DESIGN GUIDELINE PRIORITIES
OF
QUEEN ANNE DESIGN REVIEW BOARD

Meeting Date: March 5, 2008

Project Number: 3008521

Address: 301 Boren Ave. N.

ALTERNATE 3: SITE PLAN

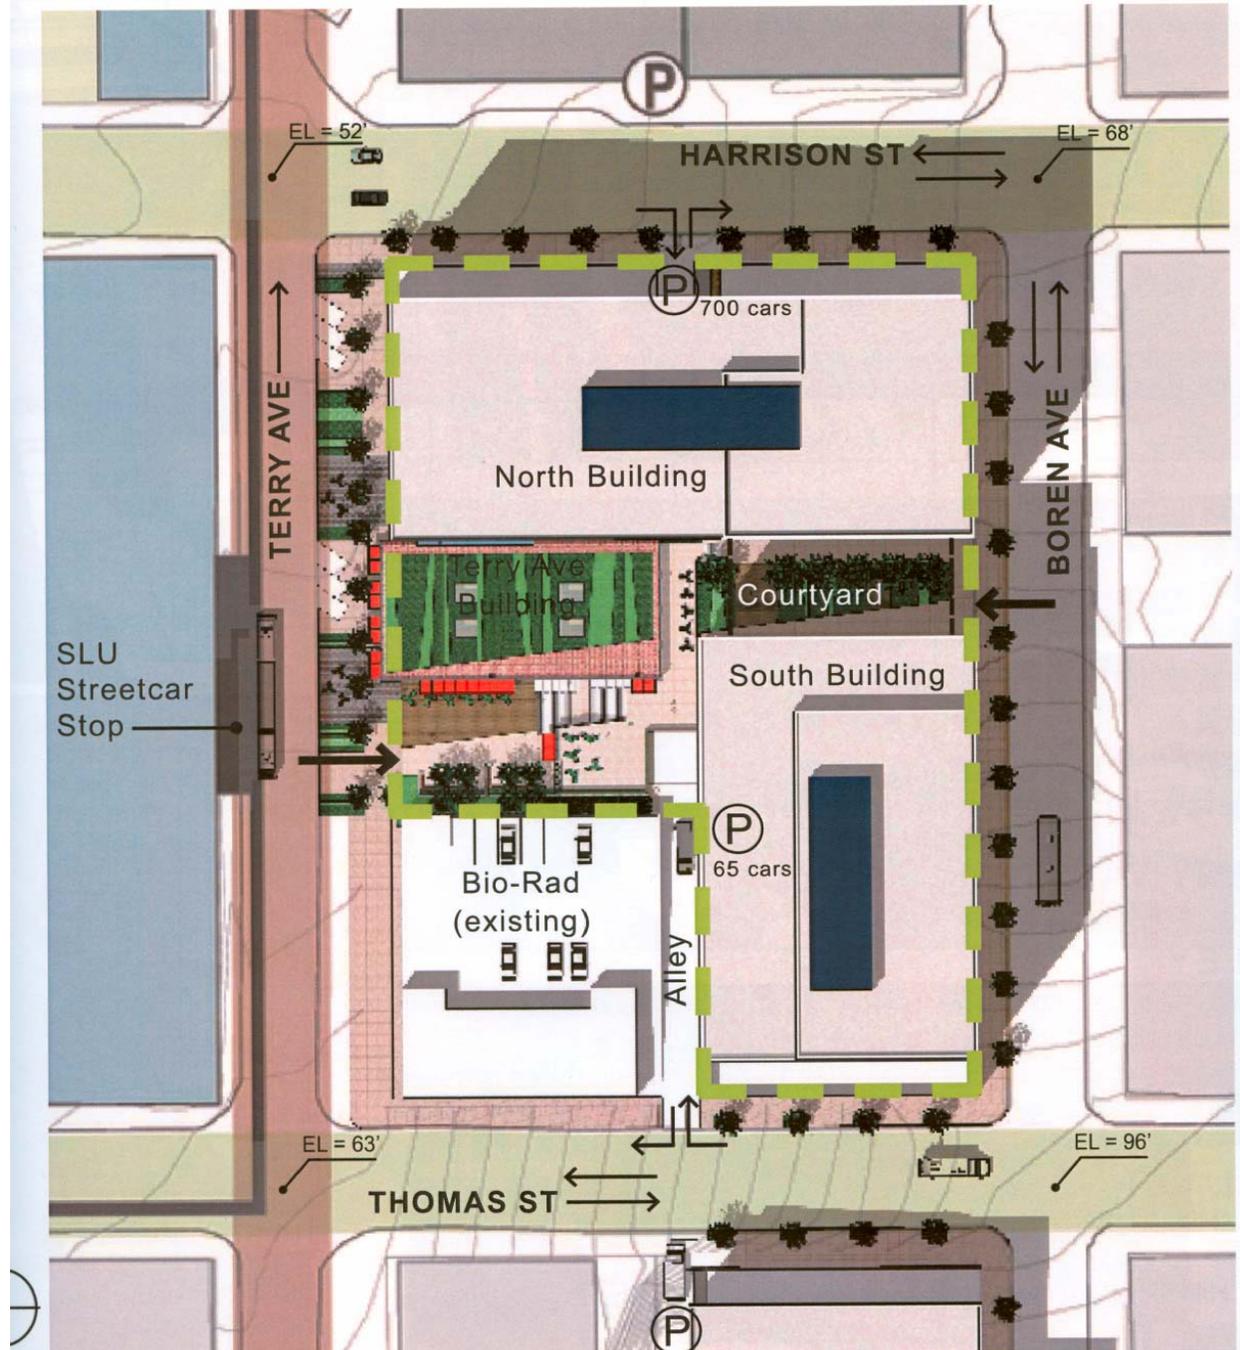
The Board did not express particular concern about the application of this guideline when presented with the preferred Option 3 massing plan. Given the proposed 120 foot height of the project and its great length along street frontages the height, bulk and scale guidelines must be kept in mind and they, like all applicable guidelines, continue to apply even without specific Board emphasis.

The Board found the design at this early design guidance level to be very well thought out and headed in a very good direction. They like the placement of the buildings in Scheme 3 with the internal pedestrian crossing and warehouse like expression of the buildings. The applicant is encouraged to move on to MUP application.

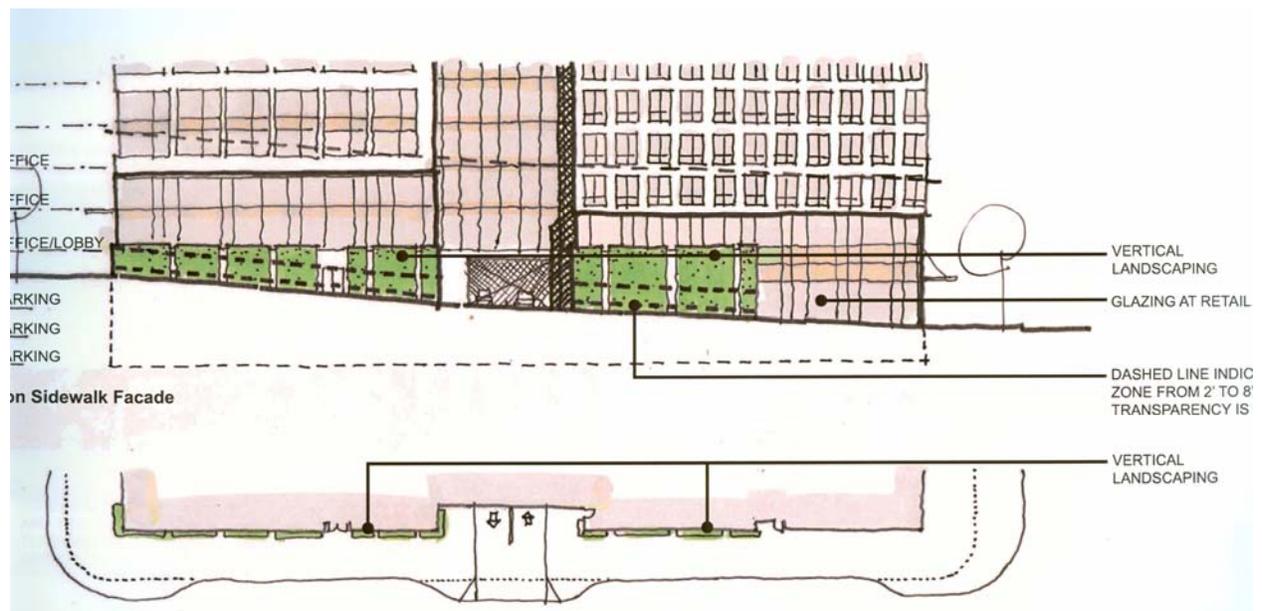
The Board encouraged the applicants to continue with the warehouse/industrial design influence indicated in the materials shown.
